CITY OF WICHITA

RE: CON2025-00168 –Amend CON2023-00028 to revise site plan for Accessory Apartment, Generally located on the west side of North 63rd Street East and within one-quarter mile north of East 77th Street North (6301 Briar Rose Lane)

CONDITIONAL USE RESOLUTION NO. CON2025-00168

STAFF REPORT

ORIGINAL SITE PLAN From 7/13/2023 MTG
(ZOOMED IN)

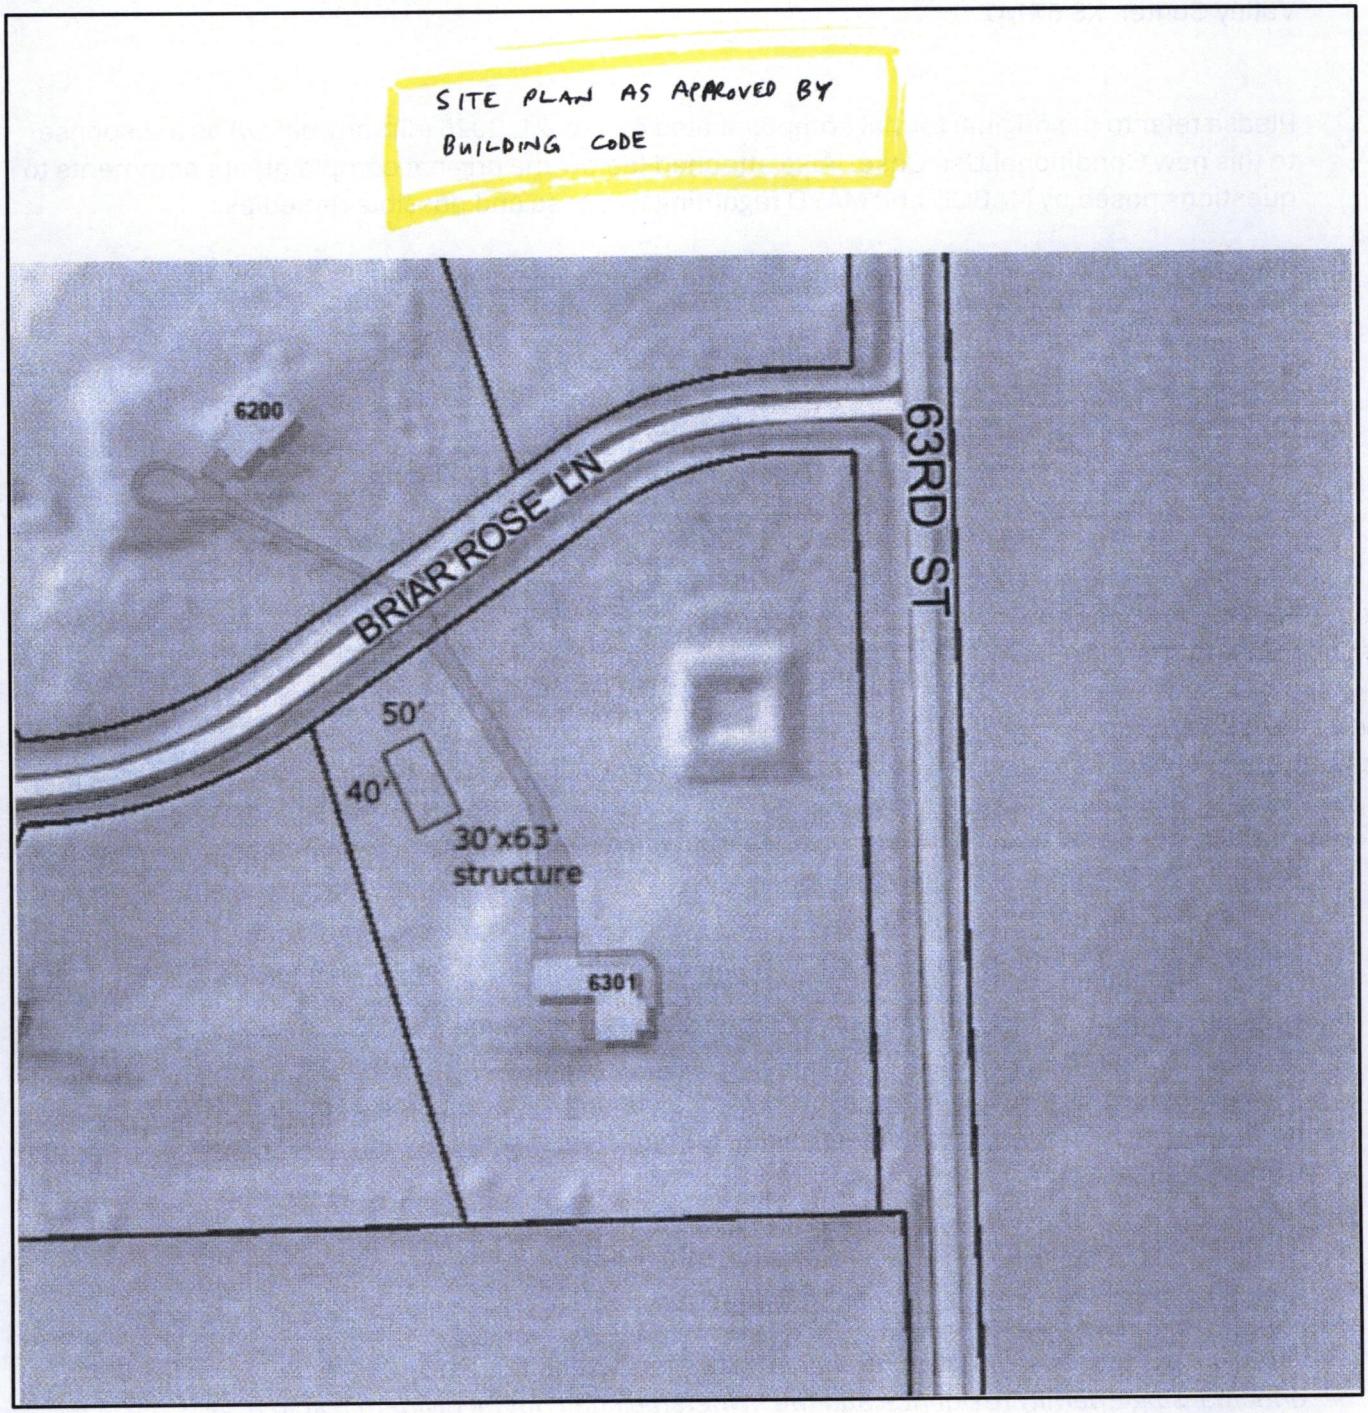
★NOTE THE TOPOGRAPHY LINES SHOWING ELEVATION CHANGE RIGHT WHERE ORIGINAL SITE PLAN LOCATION SHOWED THE STRUCTURE.

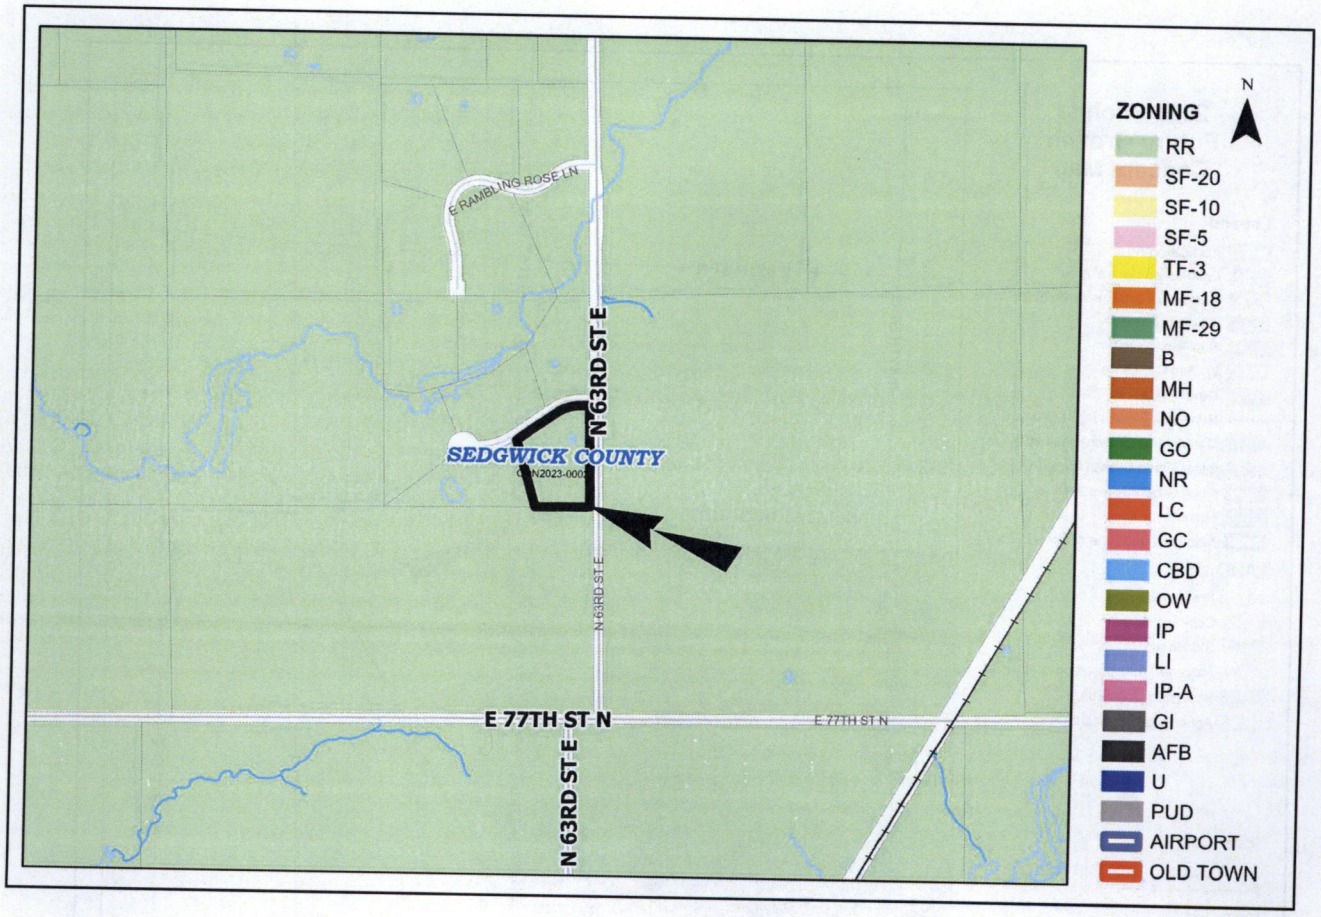
-Sightline landscape screening of Accessory Apartment driveway and garage face from approach both westbound and eastbound on Briar Rose Lane.

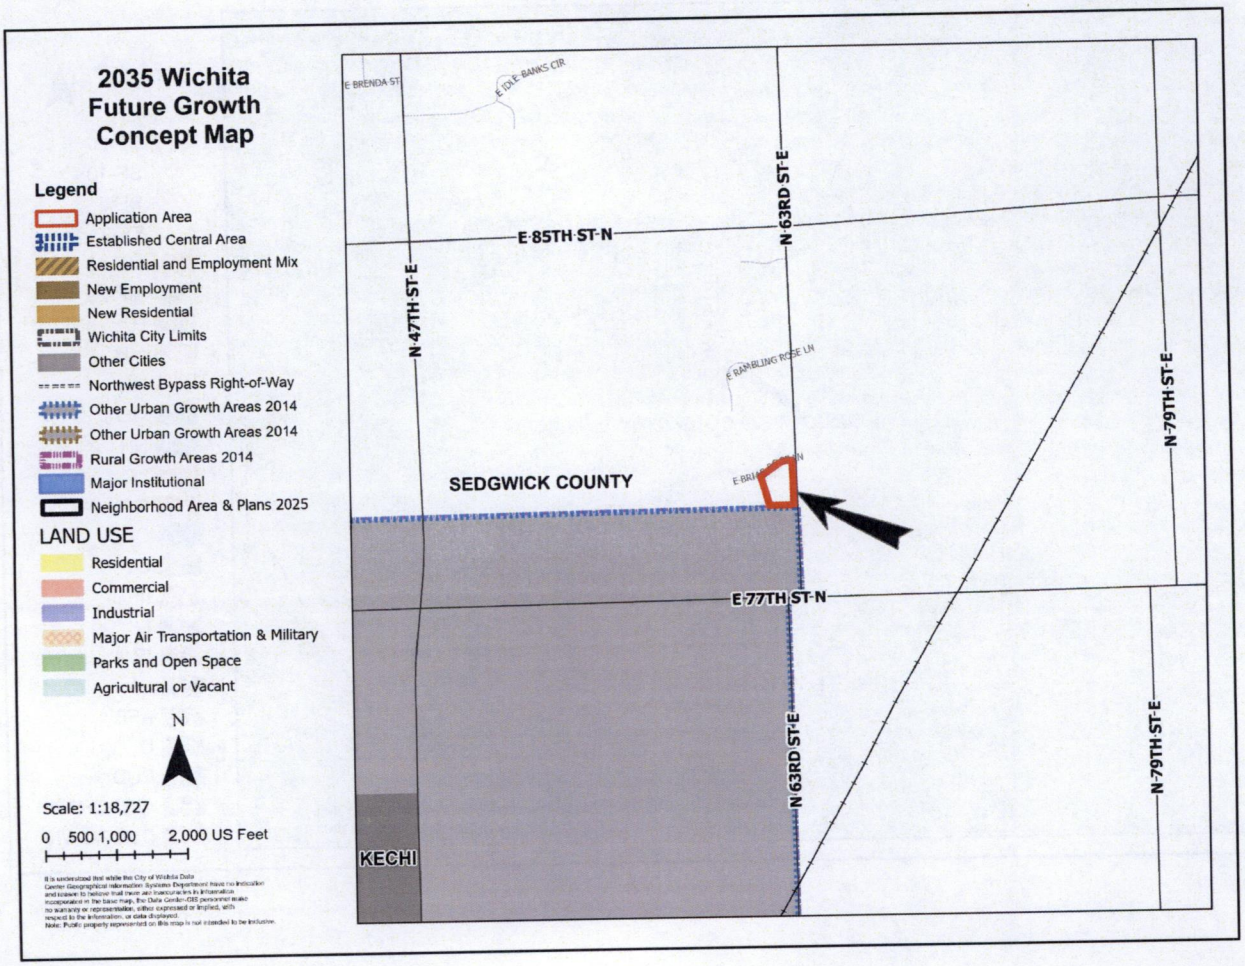
-Sightline landscape screening of Accessory Apartment driveway and garage along the north property line from the main home driveway west, to the northwest corner of the property.

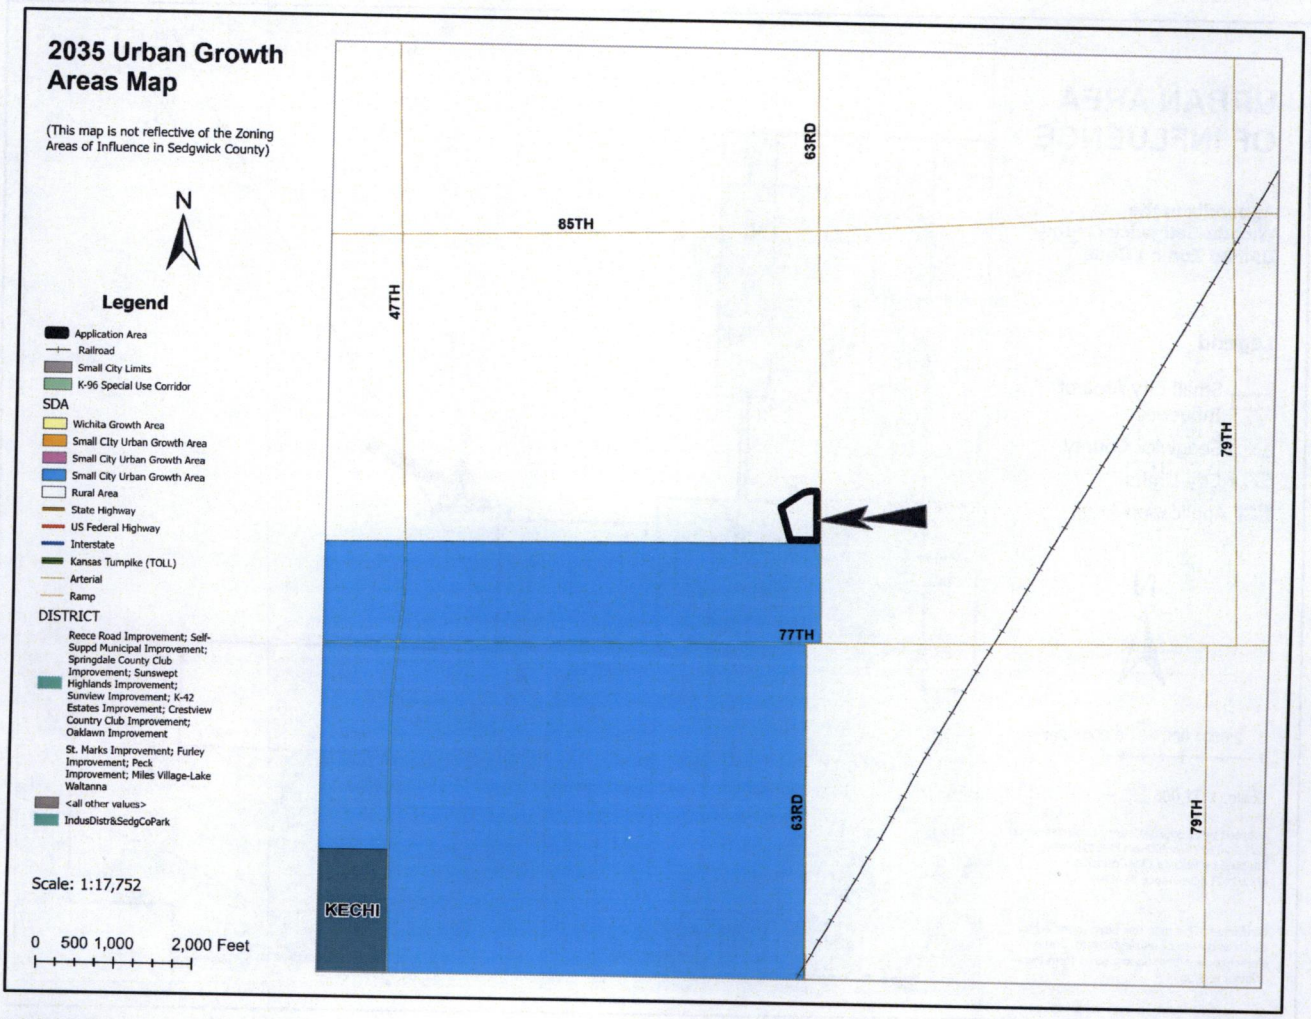
-Sightline landscape screening along the West side of the Accessory Apartment from the northwest property corner, going south, to the southwest corner of the Accessory Apartment site.
